## HISTORIC AND DESIGN REVIEW COMMISSION

**HDRC CASE NO:** 2018-155  
**COMMON NAME:** 915 S LAREDO  
**LEGAL DESCRIPTION:** NCB 310 BLK 5 LOT I & E IRR 15.5 FT OF D  
**ZONING:** C-3NA, RIO-7  
**CITY COUNCIL DIST.:** 1  
**APPLICANT:** Judith De Santiago/JD Commercial Realty  
**OWNER:** RGS Holdings, LLC  
**TYPE OF WORK:** New construction of a two story, commercial structure  
**APPLICATION RECEIVED:** March 29, 2018  
**60-DAY REVIEW:** May 28, 2018  
**REQUEST:**

The applicant is requesting conceptual approval to construct a two story commercial structure with surface parking at the corner of S Lareda Street and Guadalupe Street, in RIO-7.

1 WEST EXTERIOR ELEVATION  
1/8" = 1'-0"

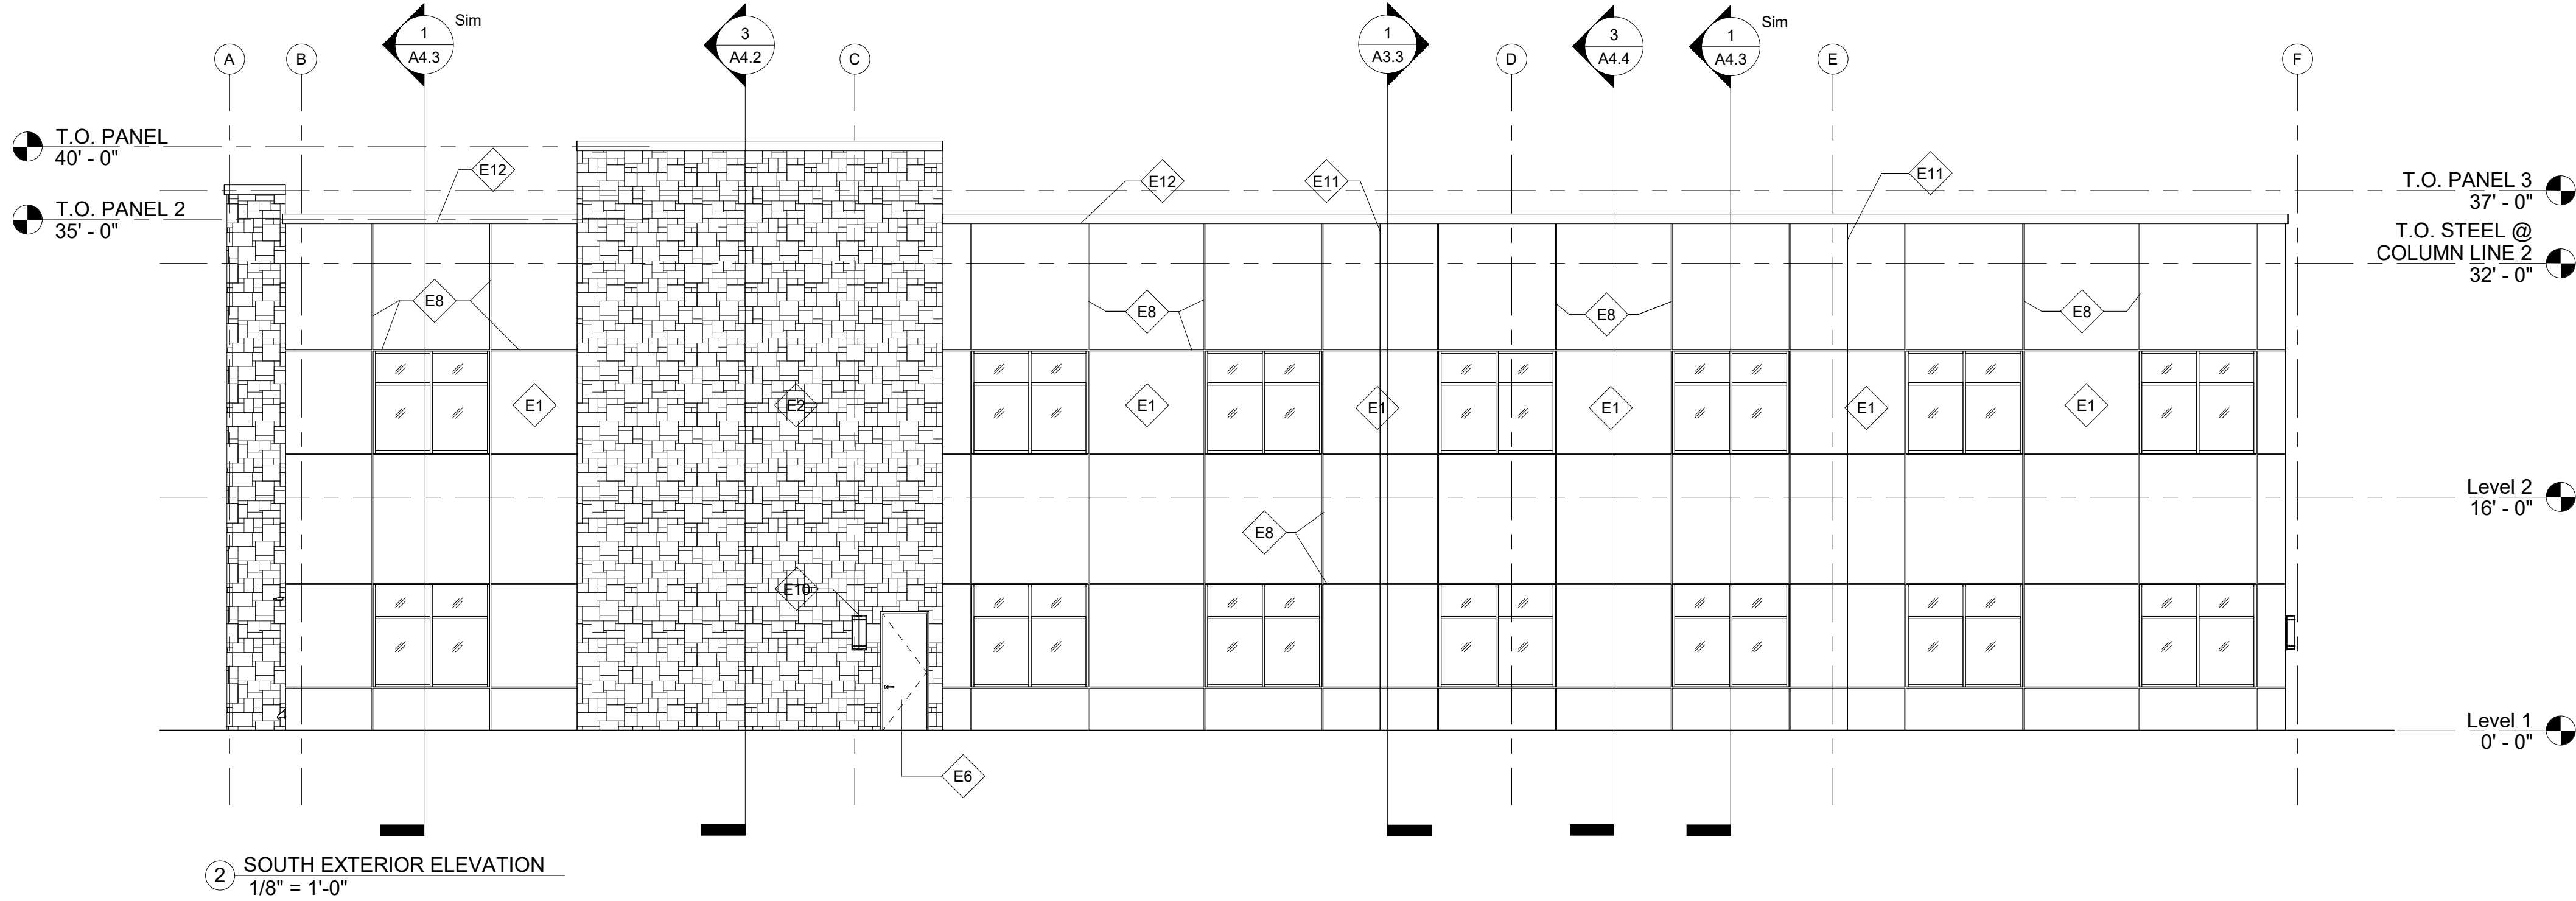
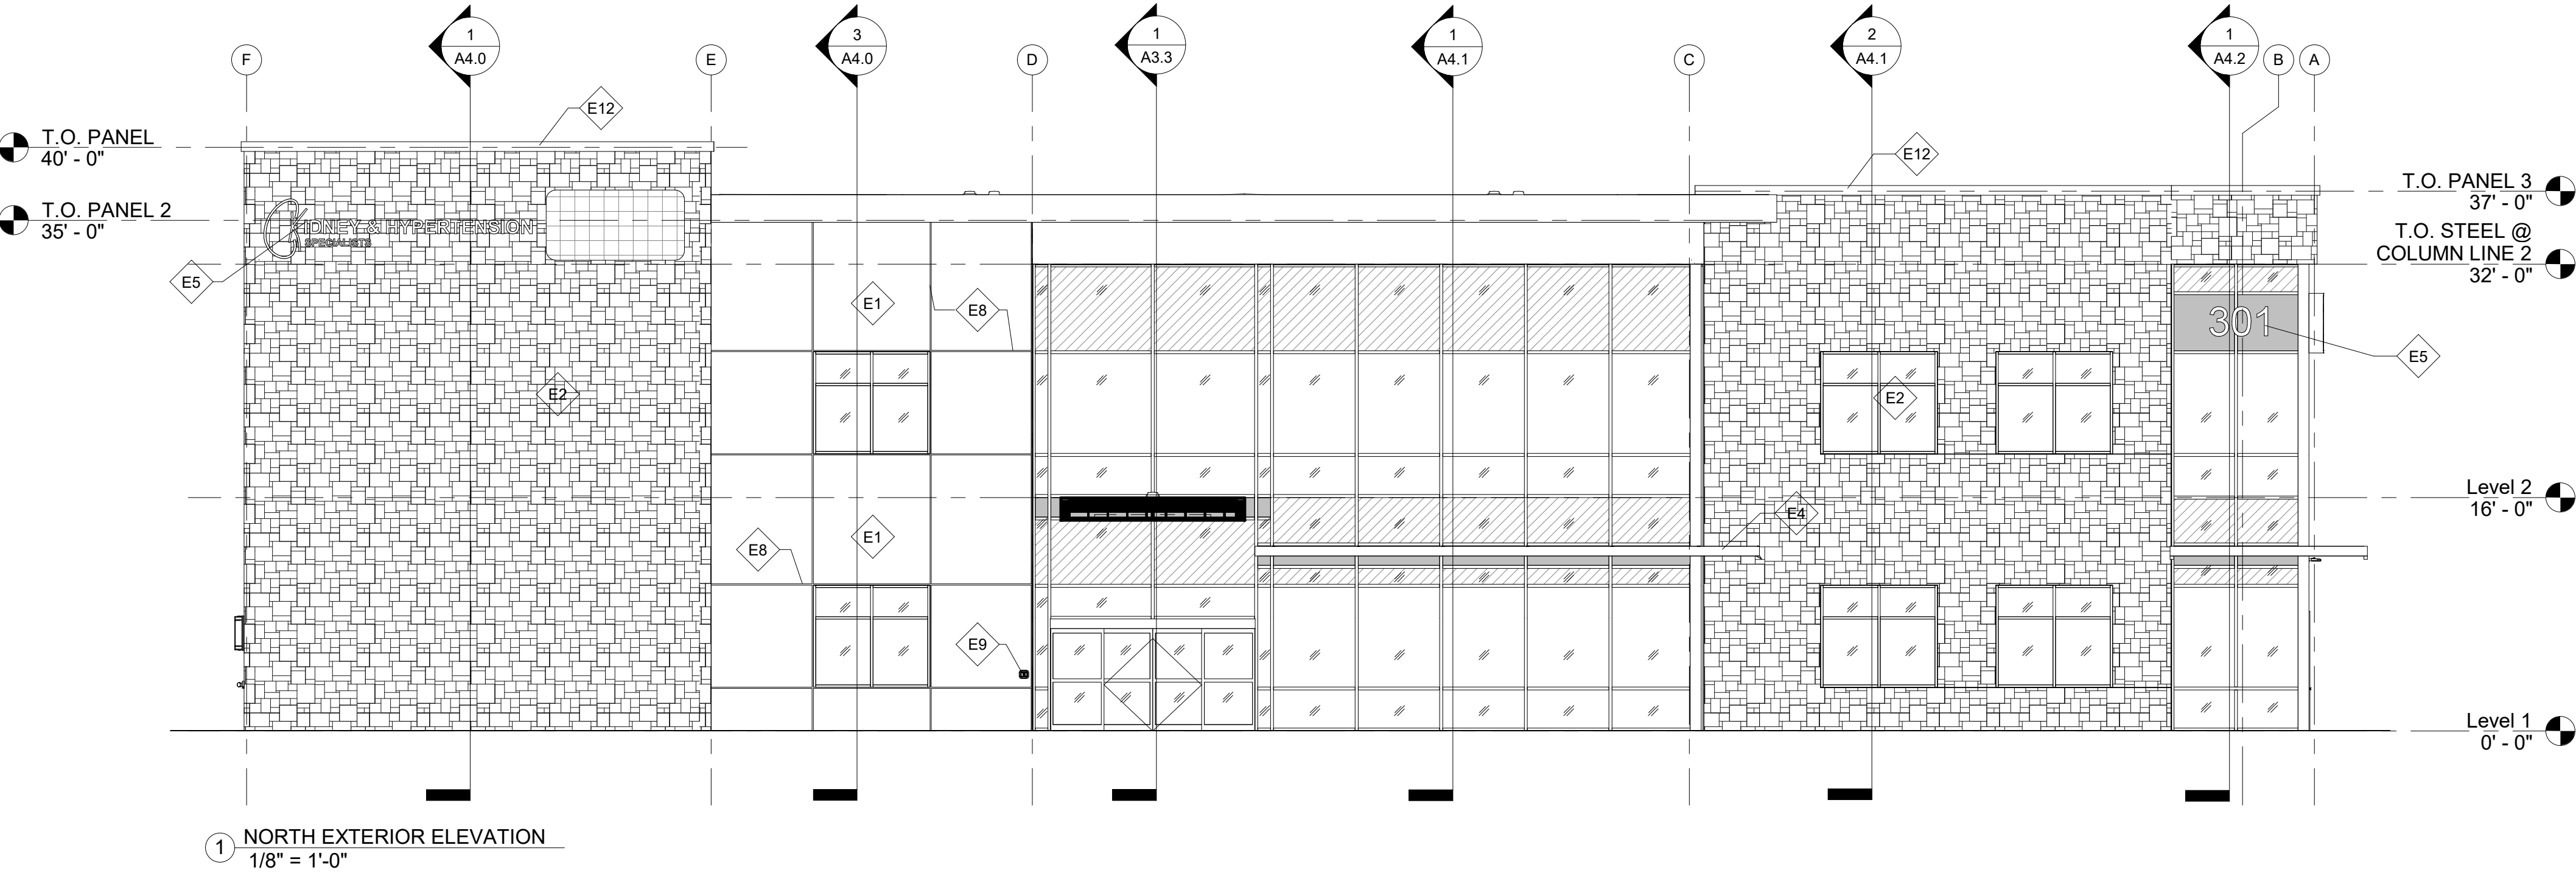
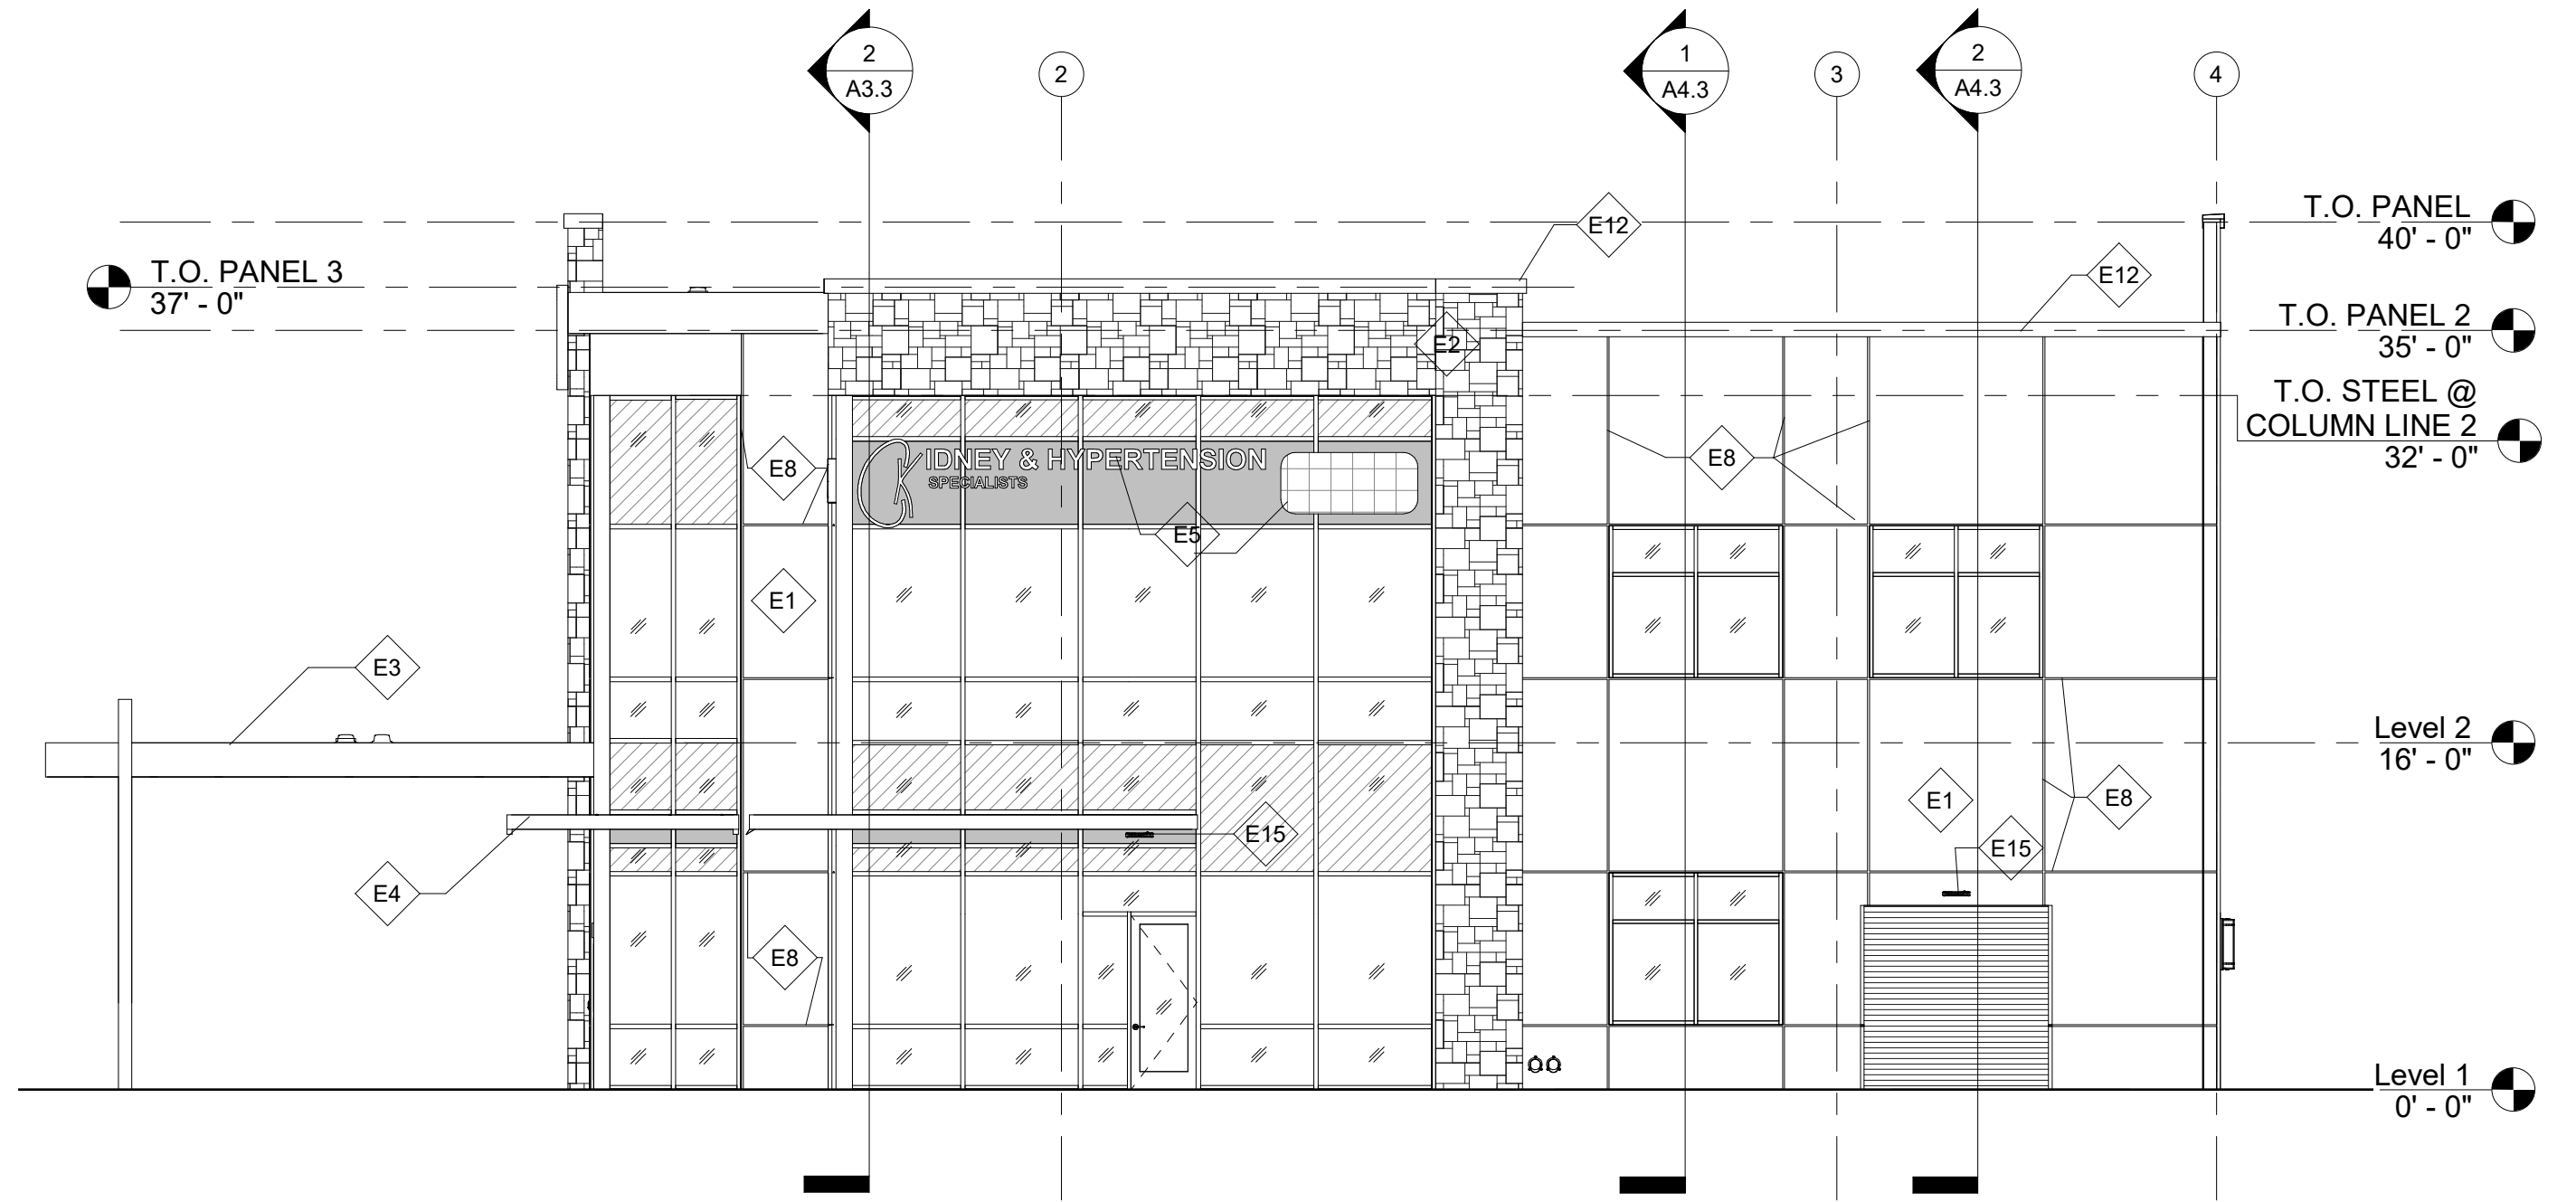
- i. **BUILDING SCALE** – According to the UDC Section 35-674(b) a building shall appear to have a “human scale”. To comply with this, a building must (1) express façade components in ways that will help to establish building scale, (2) align horizontal building elements with others in the blockface to establish building scale, (3) express the distinction between upper and lower levels, (4) in this instance, divide the façade of the building into modules that express traditional and (5) organize the mass of a building to provide solar access to the river. The applicant has incorporated elements into the design to provide a human scale including pedestrian scaled windows and storefront systems and human scaled materials. Generally, this is consistent with the UDC.

- l. **ENTRANCES** – As noted in finding f, the applicant has proposed the primary entrances to be toward the interior of the site. The UDC Section 35-674(e)(3) notes that entrances shall be the most prominent on the street side, shall be placed as to be highly visible, that the scale of the entrance is determined by the prominence of the function and or amount of use, that entrances shall have a change in material and/or wall plane and that entrances should not use excessive storefront systems. The applicant’s proposed entrances are not consistent with the UDC.

- iii. That the applicant develop landscaping and lighting plans prior to returning for final approval as noted in findings g and n.
- iv. That all windows be recessed at least two (2) inches within solid walls and that curtain wall systems shall be designed with modulating features such as projecting mullions as noted in finding k.
